ADDENDUM

ADDENDUM NO.: 03
PROJECT NAME: CDOT – Lincoln Square Brown Line Area Improvements
PROJECT NO.: 22705
CONTRACT NO.: C1612
DATE OF ISSUE: August 15, 2024

NOTICE OF CHANGES, MODIFICATIONS, OR CLARIFICATIONS TO CONTRACT DOCUMENTS

ROADWAY DETAILS
RAISED CURB CHANNELIZED BARRIER

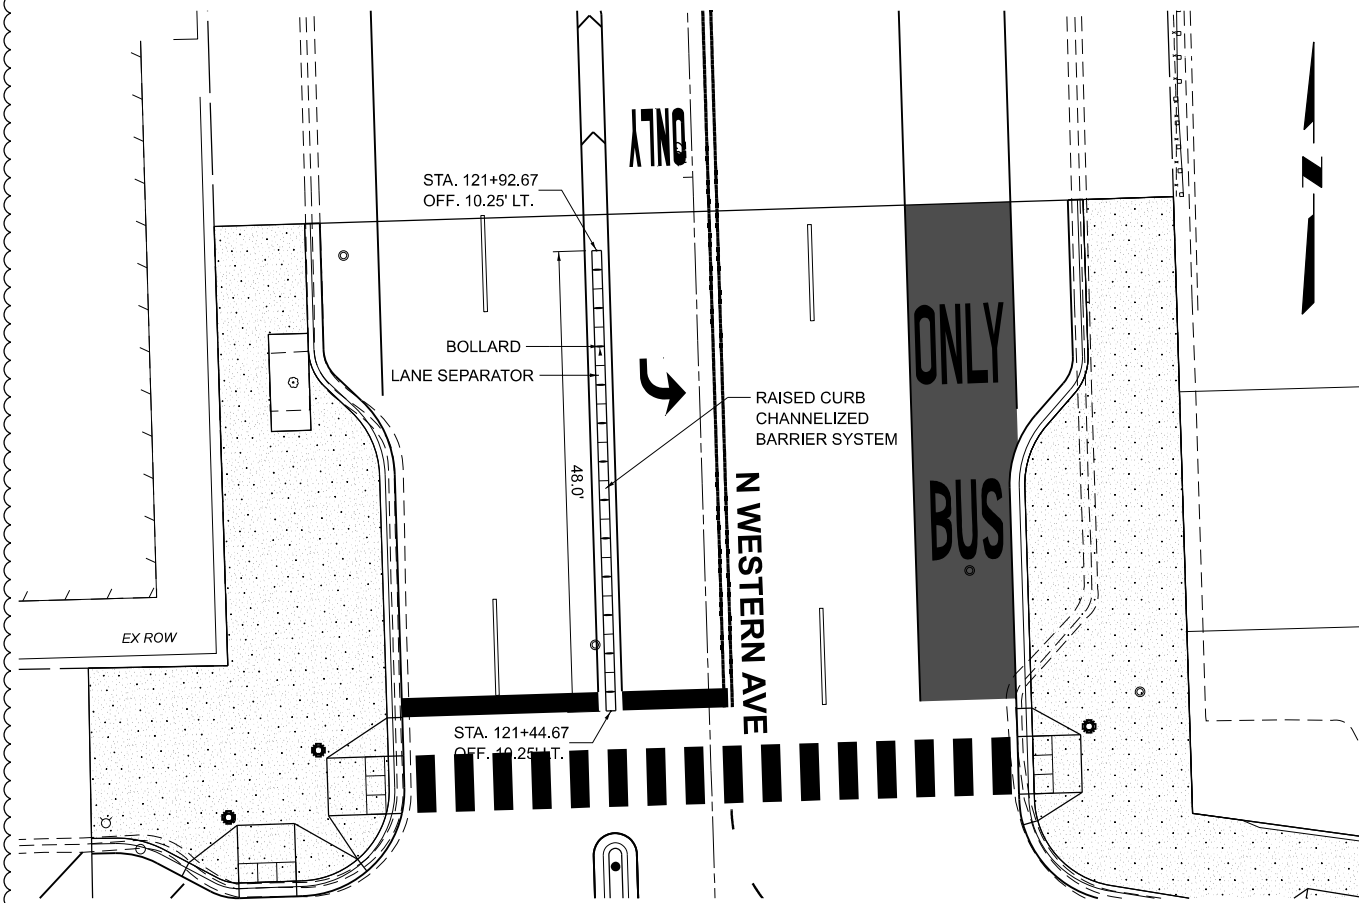
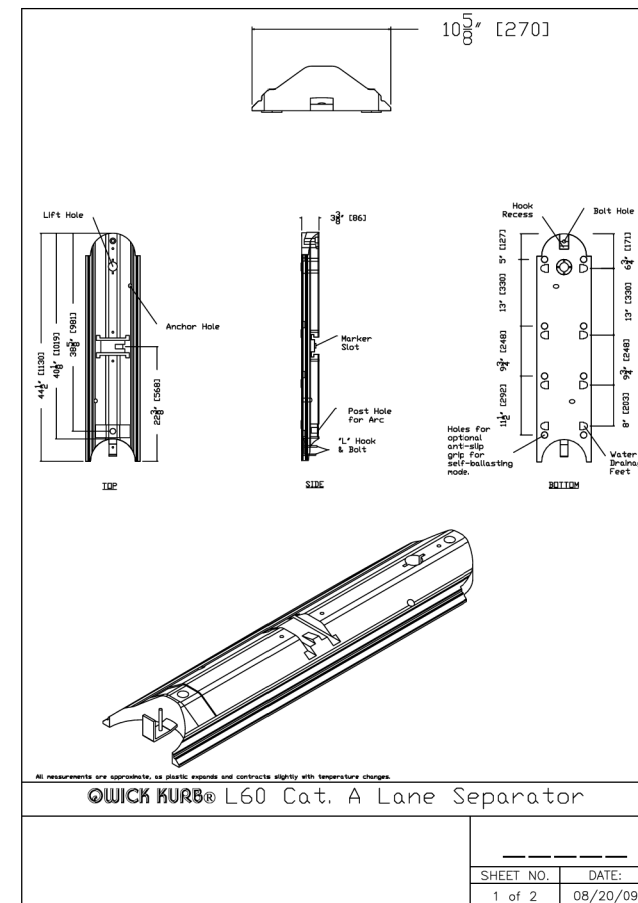
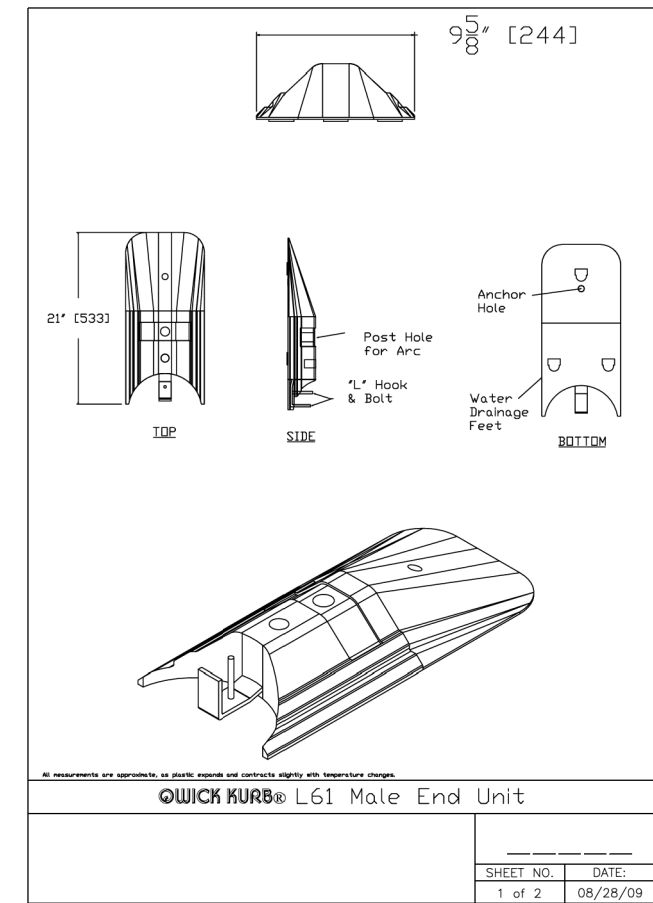
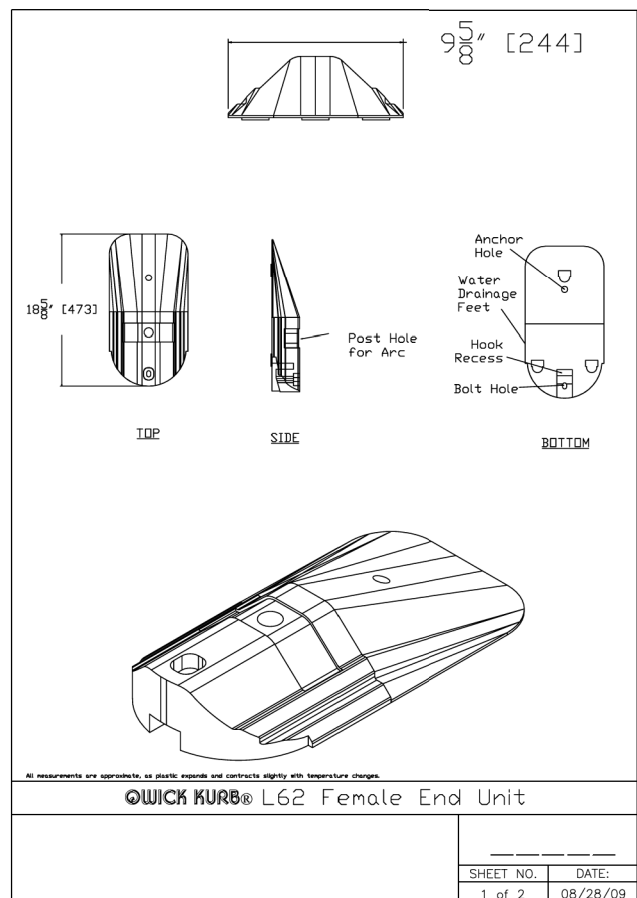
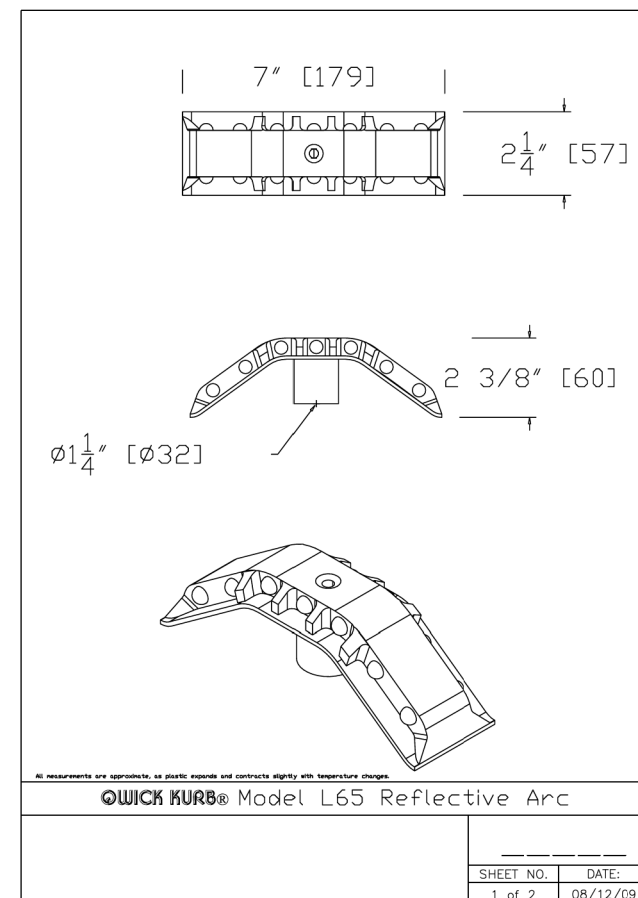
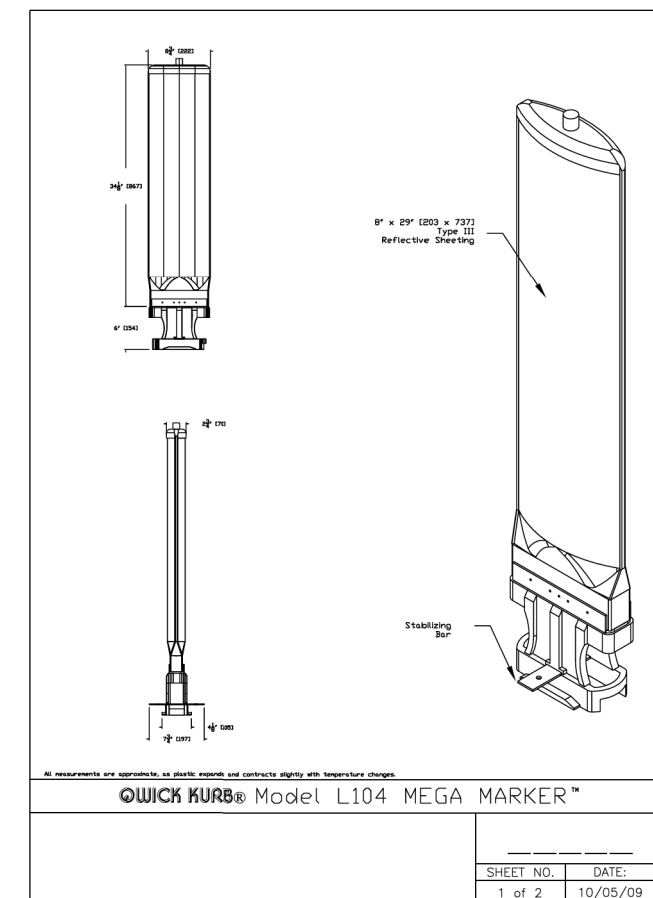
Question: Drawing PR-1 states to see Drawing DET-02 for details on Raised Curb Channelized Barrier. Please confirm if the detail shown on DET-02 is correct. Additionally, please better clarify/delineate on the detail for Raised Curb Channelized Barrier the four pay items that make up the Raised Curb Channelized Barrier:

Please confirm if the intended quantity for pay item MANUFACTURED RAISED CURB CHANNELIZED BARRIER – BASE is to be 12 EACH, as stated in the plan documents. Plan drawing only show one location for MANUFACTURED RAISED CURB CHANNELIZED BARRIER.

Response: Drawing DET-02 has been revised and is included in this addendum. Detail shows the raised curb channelized barrier system has a total length of 48'. Per the special provisions, for ease of installation, the raised separator units shall be in portable sections, 30" to 48" in length. The quantities as shown on the Master Bid Form - Schedule of Prices remain unchanged.

ROADWAY DETAILS			
N WESTERN AVE CONCRETE MEDIAN			
SCALE:	SHEET	OF	SHEETS
			PBC CONTRACT NO. C1612
			59

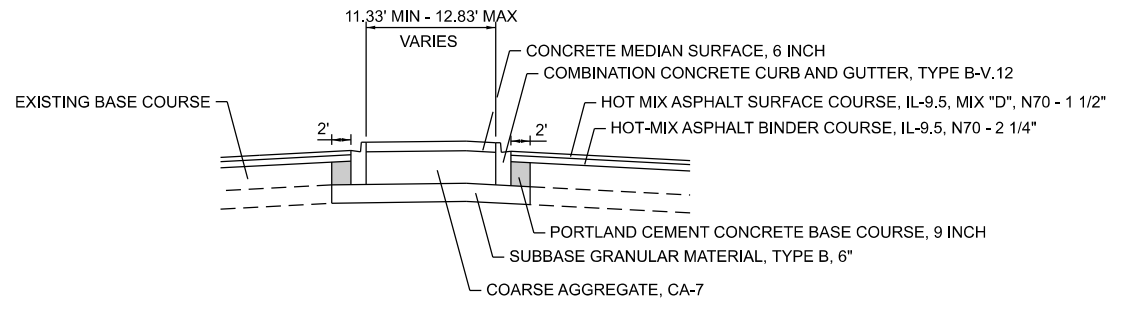
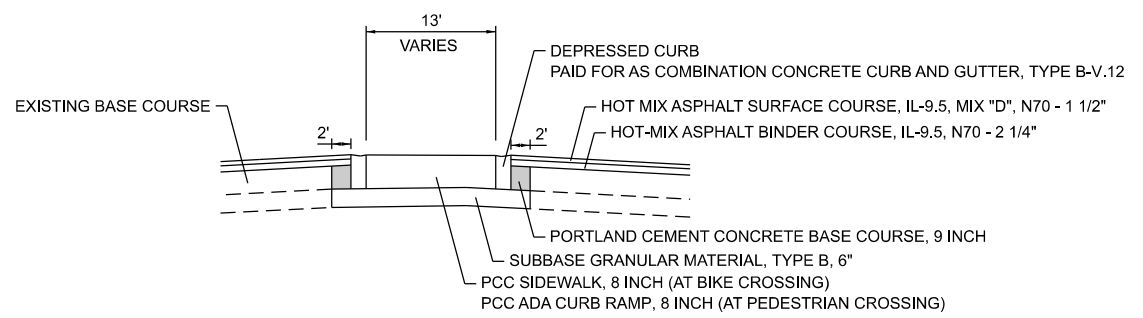
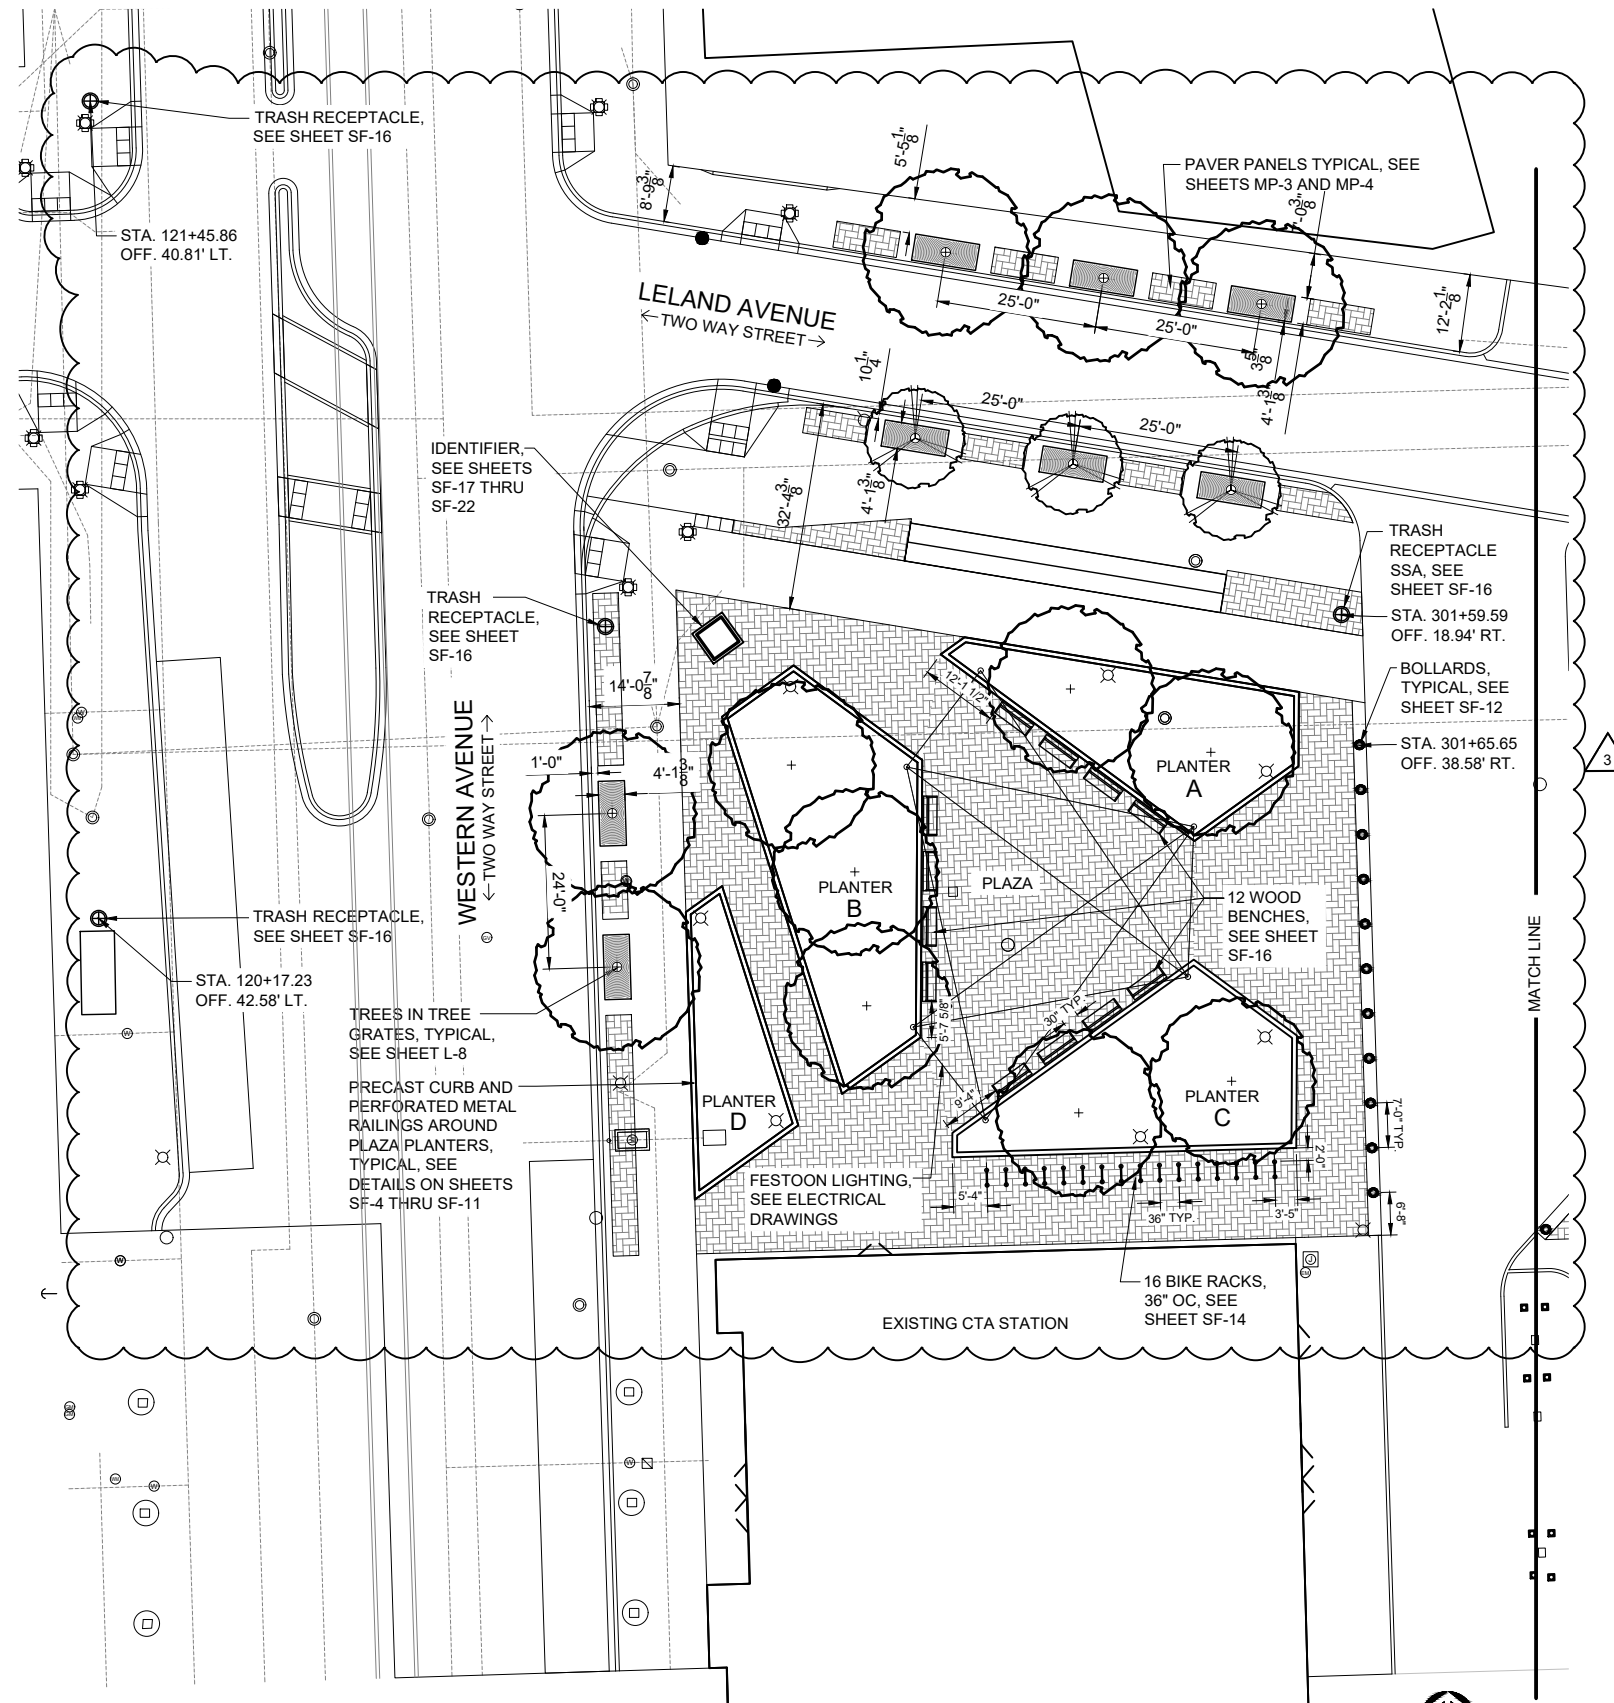
Question: Location of Pay Item CDOT4240070 - PROPERTY LINE CURB is not clearly shown on plan drawings. Please clearly identify/label location of Pay Item CDOT4240070 - PROPERTY LINE CURB.

Question: Location of Pay Item ***** - COMBINATION CONCRETE CURB AND GUTTER, TYPE M-4.12 (MODIFIED) is not clearly shown on plan drawings. Please clearly identify/label location of Pay Item ***** - COMBINATION CONCRETE CURB AND GUTTER, TYPE M-4.12 (MODIFIED). Also, please provide detail showing in what way the item is modified.

Response: [Callouts for Item CDOT4240070 – PROPERTY LINE CURB have been added on Drawing DET-03. Drawing DET-03 has been revised and is included in this addendum.](#)

Response: [Callouts for Item Pay Item ***** - COMBINATION CONCRETE CURB AND GUTTER, TYPE M-4.12 \(MODIFIED\) have been added on Drawing DET-03. Drawing DET-03 has been revised and is included in this addendum.](#)
